CITY OF ALBUQUERQUE

Re: Dunkin Donuts
2301 Juan Tabo Blvd., NE
Traffic Circulation Layout
Engineer's/Architect's Stamp dated 1-6-16 (H21-D051)

Based upon the information provided in your submittal received 1-7-16, the above referenced plan cannot be approved for Building Permit until the following comments are addressed:

SP-1

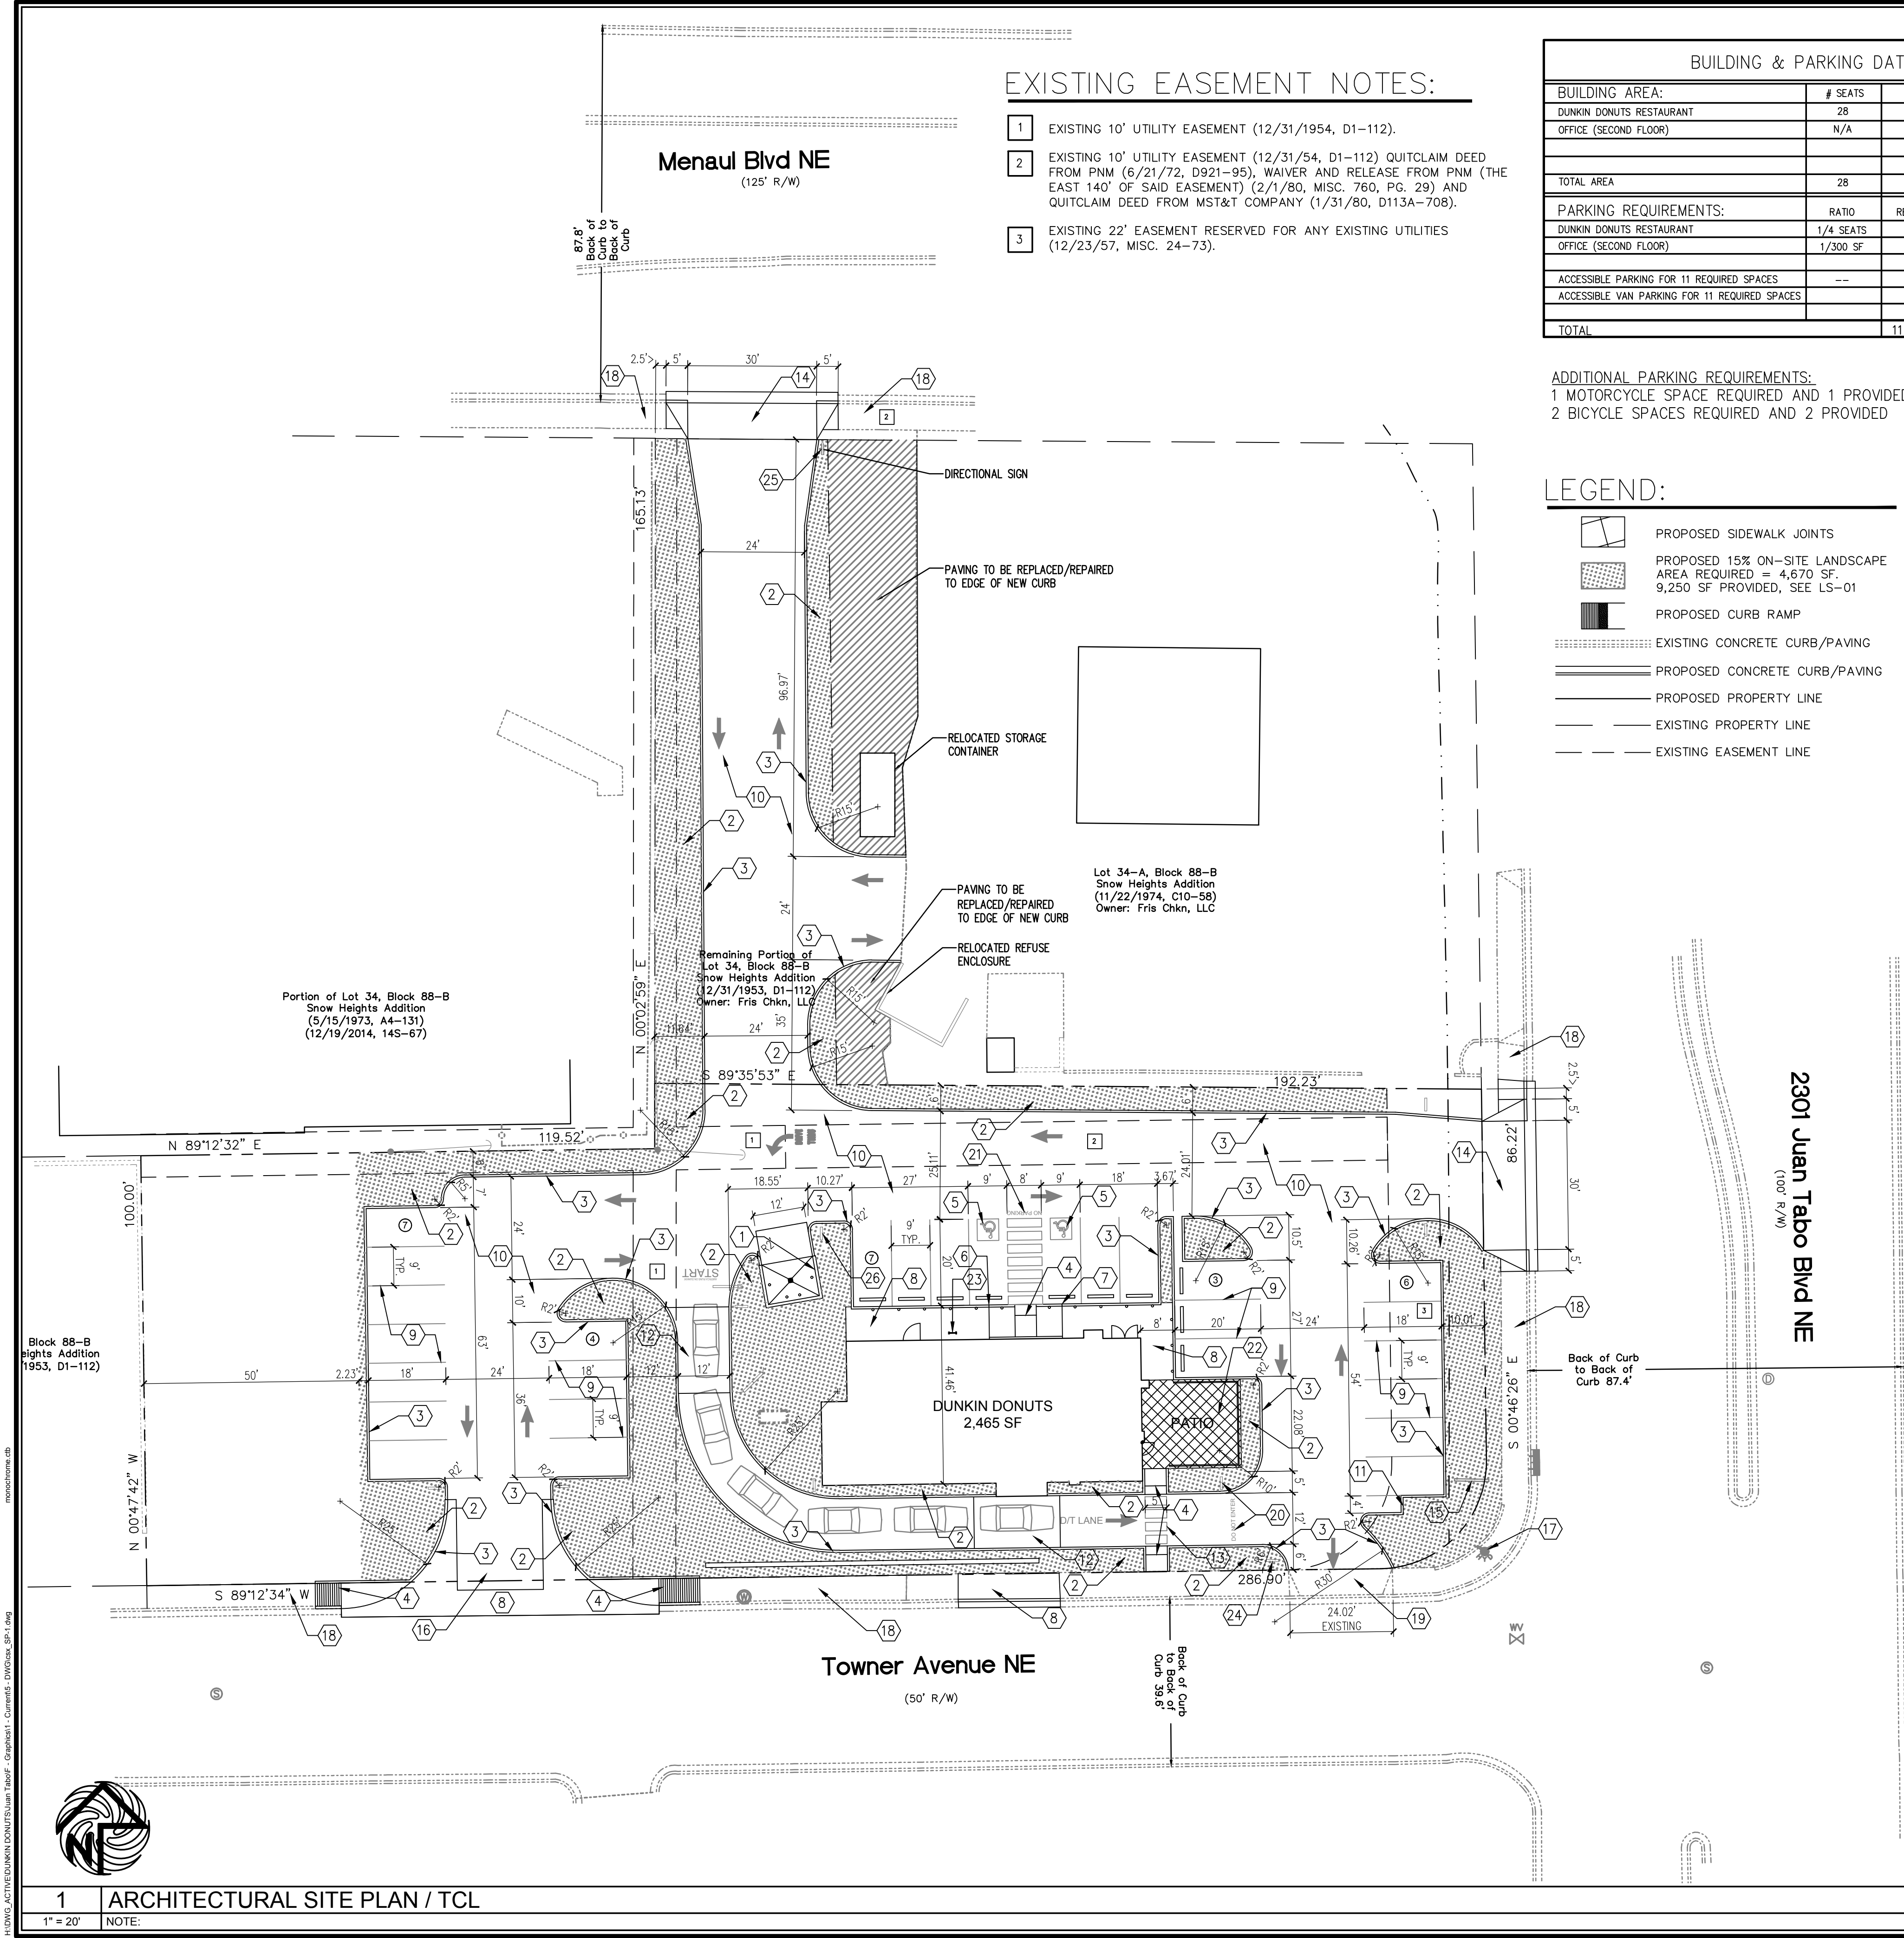
1. Please dimension and detail all existing sidewalks, right of ways and ADA access ramps per COA standard drawing. Please attach Site Detail Sheet.
2. Per the DPM, a 6 ft. wide ADA accessible pedestrian pathway is required from the public sidewalk to the building entrances. Please add sign at the south side of building at the end of the Drive Thru and before the ADA pedestrian crossing to building entrance informing vehicles to not stop or block this area.

3. Per the DPM, a 6 ft. wide ADA accessible pedestrian pathway is required from the HC parking stall access aisles to the building entrances. Please clearly show the sidewalk dimension.

4. Service vehicle and/or refuse vehicle maneuvering must be contained on-site; provide a copy of refuse approval.
5. One-way vehicular paths require pavement directional signage and a posted **"Do Not Enter"** sign at the point of egress. Please add sign at south east entrance off of Towner Ave.

6. Please provide a sight distance exhibit (see the *Development Process Manual, Chapter 23, Section 3, Part D.5 Intersection Sight Distance*). Please show this detail for entrances/exits at Towner Ave., Menaul Blvd., and Juan Tabo Blvd.

7. Please add the following note to the clear sight triangle: "Landscaping and signage will not interfere with clear sight requirements. Therefore, signs, walls, trees, and shrubbery between 3 and 8 feet tall (as measured from the gutter pan) will not be acceptable in this area."
8. All broken or cracked sidewalk must be replaced with sidewalk and curb & gutter. A build note must be provided referring to the appropriate City Standard drawing.
9. Please include two copies of the traffic circulation layout at the next submittal.
